**SUBJECT: Compliance Recall 17C09**

Certain 2015-2017 Model Year F-150 and 2017 Model Year F-250 – F-550 Vehicles  
 Fitted with Ford Accessory Chrome Exterior Door Handle Trim Covers  
 Remove and Discard Ford Accessory Chrome Exterior Door Handle Trim Covers

**CERTAIN 2015-2017 MODEL YEAR F-150 AND 2017 MODEL YEAR F-250-F-550 VEHICLES FITTED WITH FORD ACCESSORY CHROME EXTERIOR DOOR HANDLE TRIM COVERS — REMOVE AND DISCARD FORD ACCESSORY CHROME EXTERIOR DOOR HANDLE TRIM COVERS**

**FIGURE 1**

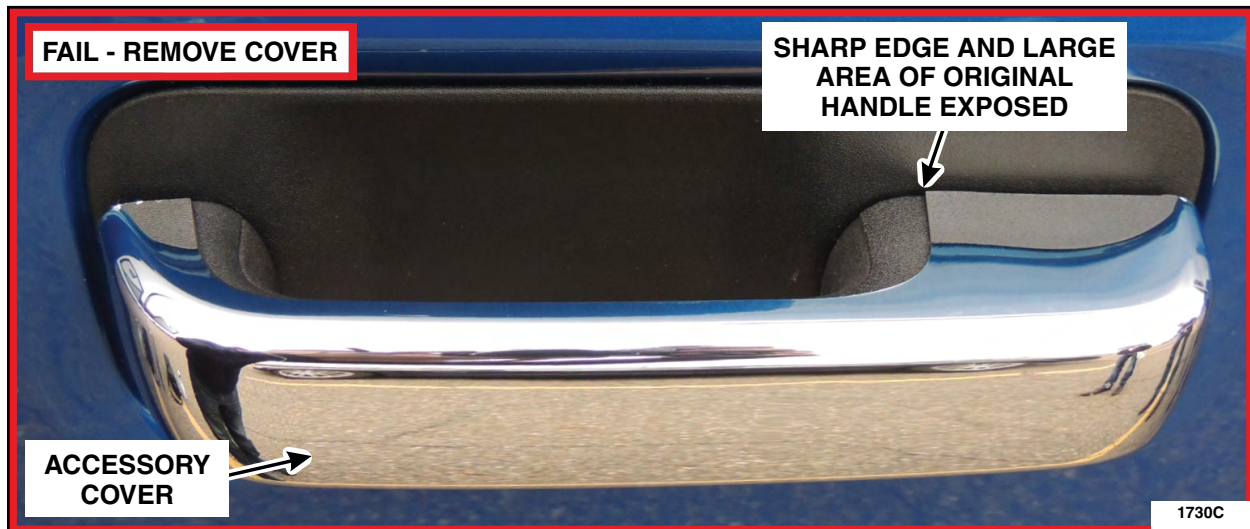
Figure 1 - Black door handle with graining. Only the Ford Accessory chrome exterior door handle cover is installed. Cover removal required, refer to the Service Procedure on Page 3.

1. Remove and discard the Ford Accessory chrome exterior door handle/bucket trim covers from all doors. See Figure 5.
  - a. Use a heat gun to loosen the handle/bucket trim cover adhesive.
  - b. Remove and discard the covers/buckets using a plastic trim removal tool.
  - c. Remove any remaining adhesive with your hands and then clean the door handle with a clean cloth and isopropyl alcohol.

FIGURE 2

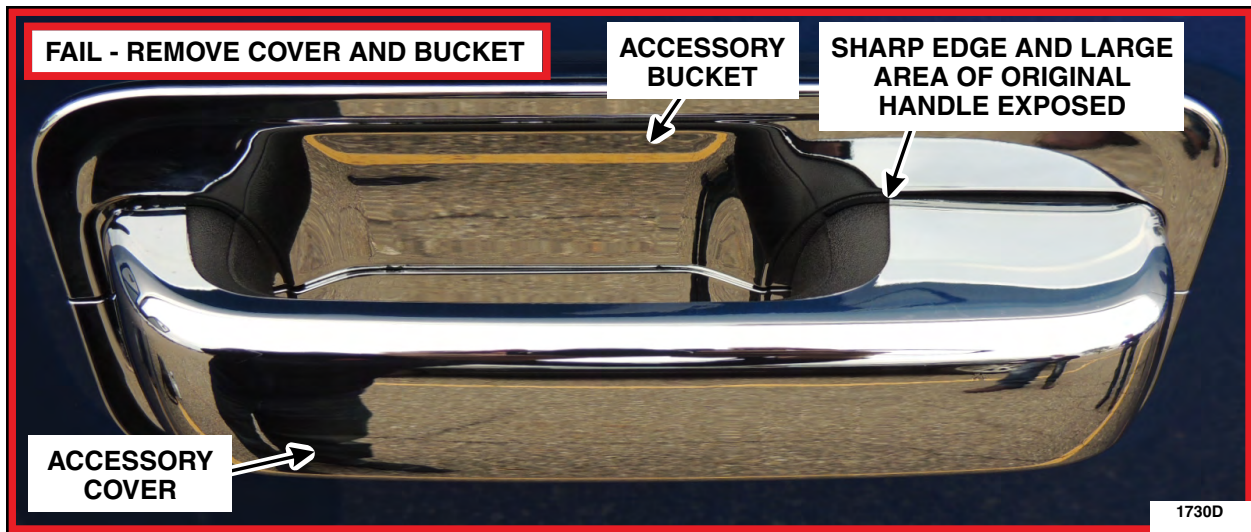
Figure 2 - Black door handle with graining. The Ford Accessory chrome exterior door handle cover and bucket are installed. Cover and bucket removal required, refer to the Service Procedure on Page 3.

FIGURE 3

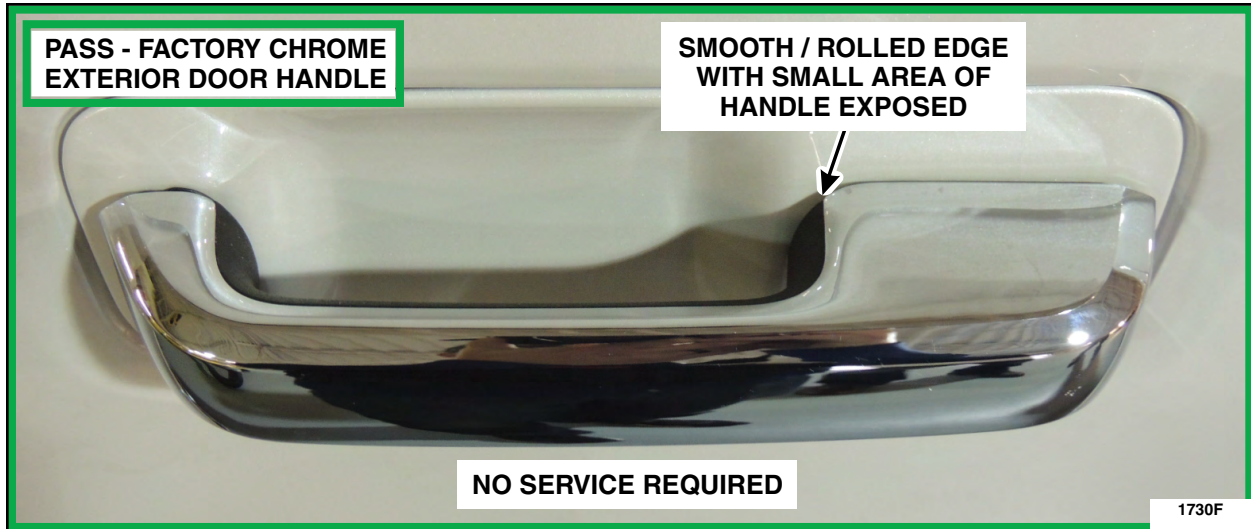
Figure 3 - Painted door handle. Only the Ford Accessory chrome exterior door handle cover is installed. Cover removal required, refer to the Service Procedure on Page 3.
